TO: Service Locations

FROM: Service Operations

SUBJECT: **Aftertreatment Replacement**

Figure 1 – Former EPA10 and New Temperature Sensors Wire Routing

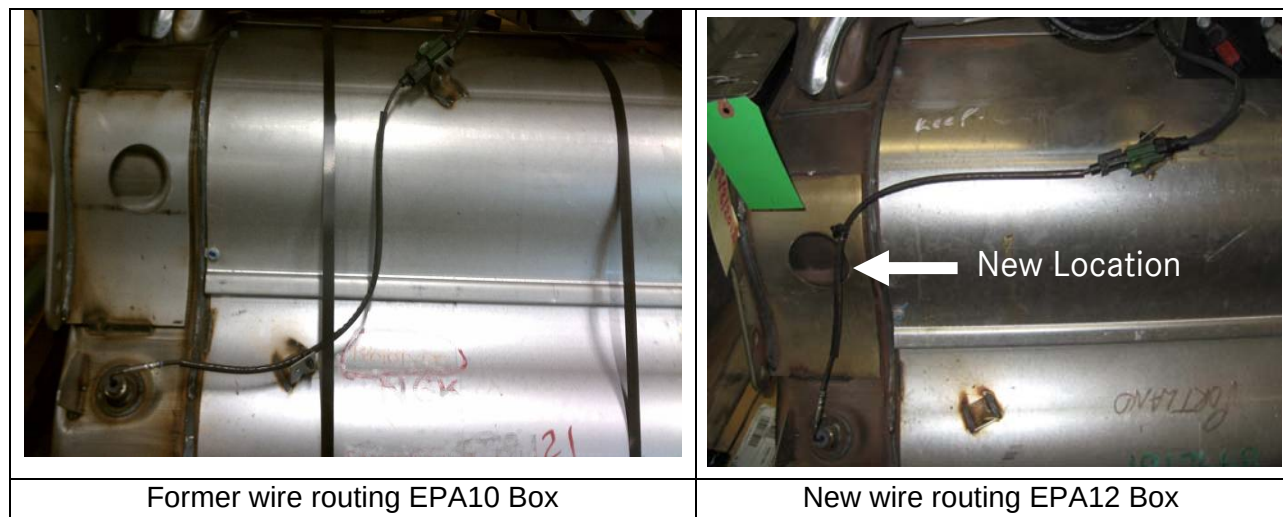
The model year 2010 1-Box™ emission packages are being phased out and will no longer be available as a service replacement unit. In the event a service replacement module 1-Box configuration is required, it will be replaced with a model year 2012 1-Box. All components are transferable and can be installed on the 2012 1-Box. When transferring components, the only difference between the 2010 and 2012 1-Box is the relocation of Selective Catalyst Reduction (SCR) outlet temperature sensor harness clipping points. The upper SCR heat shields clipping point is still utilized along with the new clipping point located directly above the SCR inlet temperature sensor, as illustrated in Figure 1.
